## IDAP REPORT

<b>Property:</b>	14 Broughton Road Strathfield LOT 1 DP 923396 DA2022/17
<b>Proposal:</b>	Demolition of existing structures and the construction of new double storey home with basement parking, in-ground swimming pool and associated landscaping.
<b>Applicant:</b>	C Lam
<b>Owner:</b>	MNL & C Lam
<b>Date of lodgement:</b>	2 February 2022
<b>Notification period:</b>	8 February 2022 - 24 February 2022
<b>Submissions received:</b>	2 written submissions received
<b>Assessment officer:</b>	L Gibson
<b>Estimated cost of works:</b>	\$1,023,211.00
<b>Zoning:</b>	R2-Low Density Residential - SLEP 2012
<b>Heritage:</b>	No, however immediately adjoins a heritage listed item " <i>Noveba</i> "— <i>Victorian Italianate style house</i> (16 Broughton Road, Strathfield) and the <i>Broughton Road Conservation Area, Federation houses group</i> listed under Schedule 5 of the SLEP 2012
<b>Flood affected:</b>	Yes
<b>Is a Clause 4.6 Variation Proposed:</b>	N/A

Figure 15: Original proposal siting behind prevailing front building line of existing dwellings in the streetscape.

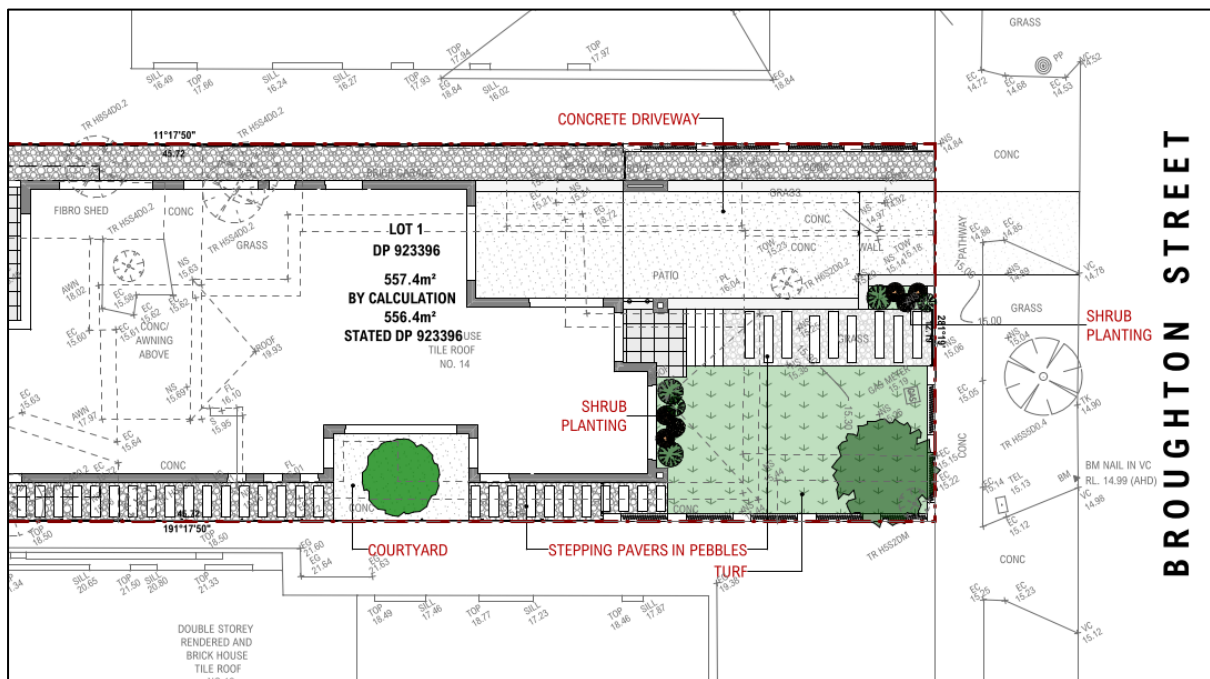
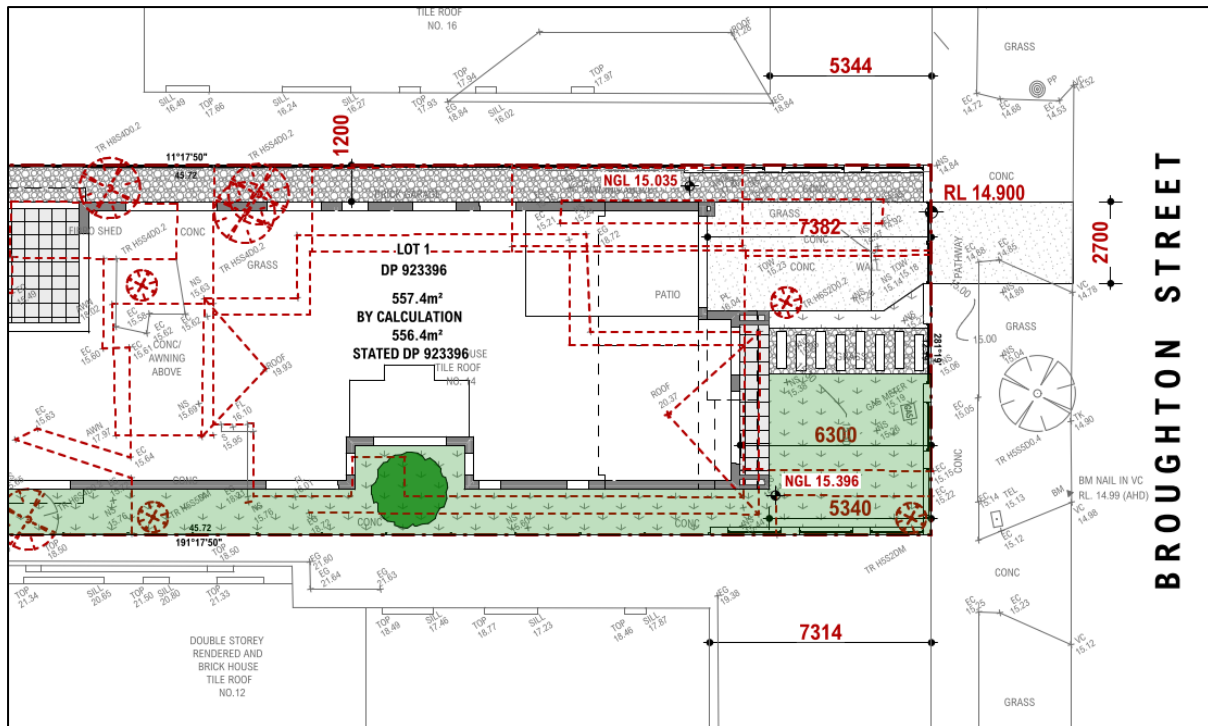
The front setback has been revised throughout the assessment process so to more closely align with the established front setbacks of dwellings along the street (Figure 13, 14, 15 and 16). This enables the dwelling to better integrate with the prevailing bulk, massing, setbacks and scale of existing development in the street, including but not exclusive to, surrounding heritage items.

Figure 13: Original proposal presenting as a two (2) storey dwelling with generous setback sitting well behind the established building line along the street.

Figure 14: Amended proposal presenting as a single storey dwelling to the street and aligns more closely with that of existing dwellings in the streetscape.

Figure 16: Revised proposal showing dwelling now more closely aligning with adjoining dwellings and that of the original dwelling's footprint.
